Second Quarter 2007 Progress Report
Midwest Roadside Safety Facility
Mid-States Regional Pooled Fund
July 27, 2007

Request for Feedback from the States

Development of a Temporary Concrete Barrier Transition

32" Temporary F-Shape
Barrier to 32" Median TX
Single-Slope Barrier

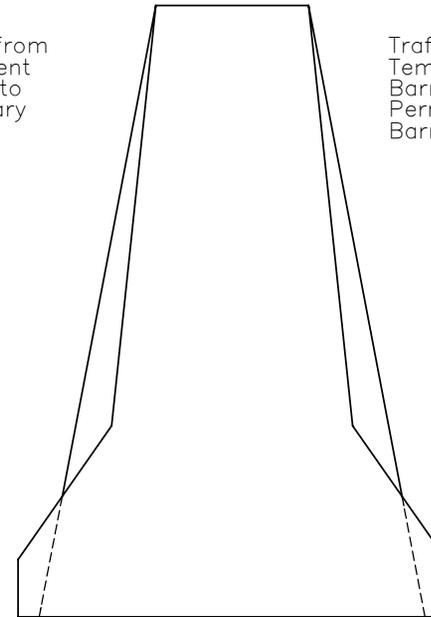
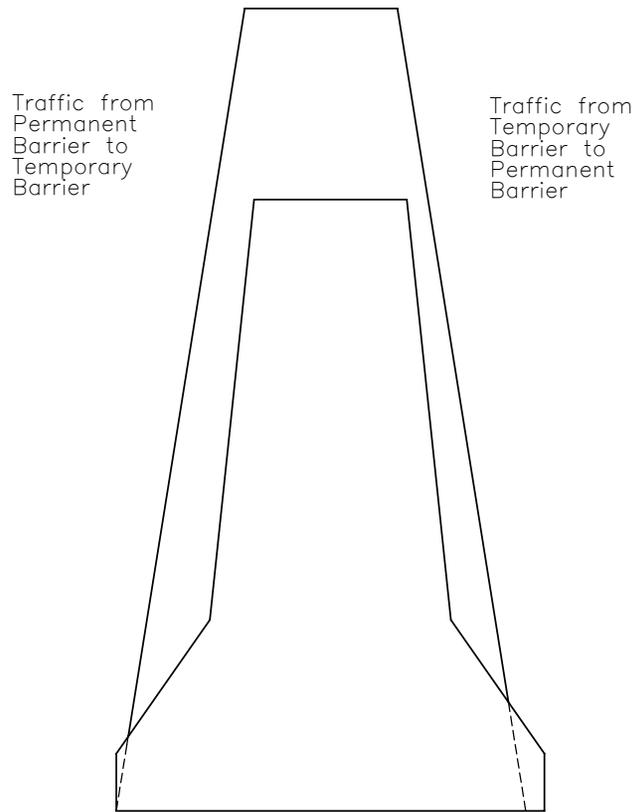
- 1) The transition to barriers that are in excess of 32" in height will be a greater challenge. Note that approach guardrail transitions are normally designed to connect to 32-34 in. high barriers. A temporary barrier transition to a 42" high barrier would normally only be needed when a taller permanent barrier is planned to replace the temporary barrier. Is developing the transition for 42" barriers important?

- 2) If we are allowed to offset the center line of temporary barrier from the center line of the permanent barrier it will be easier to develop the transition, but will also make the transition asymmetrical. This is shown in the attached drawings. Asymmetrical placement should only be an issue if the temporary barrier is used to separate traffic flowing in the same direction, such as in a gore area. However, a barrier end treatment makes more sense in this type of application. Is this a significant enough issue to warrant keeping both sides symmetrical?
